Product Quality Notice

Notice number: **PQN-10**

Affected product: **GA124 - all models**

Subject: **Missing jumper plug on GA124 boiler**

Fig. 2 Jumper plug location inside Aquasmart control

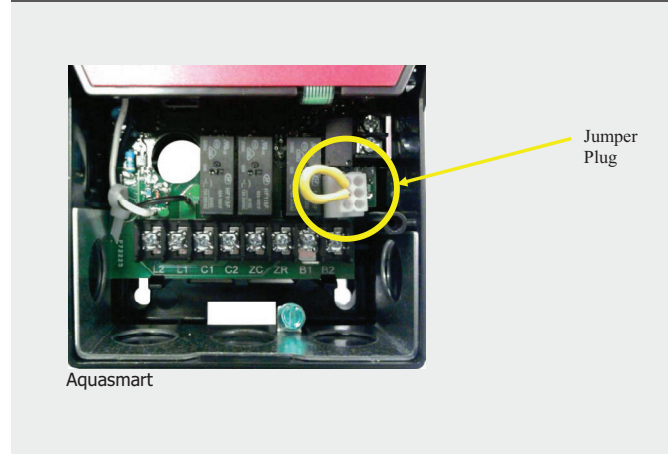
GA124 boilers produced between April 2013 and May 2013 (FD 304 – 305) were shipped missing the jumper plug on the 6-position vent damper receptacle on the Aquasmart control. The GA124 boiler does not require a vent damper. The jumper plug is necessary for the boiler to run.

All boilers in inventory have been reworked and production has been corrected to include the jumper plug on future shipments.

If a customer suspects they may have an affected boiler they can contact technical support at 1-800-283-3787 for a free of charge jumper plug or to make alternate arrangements.
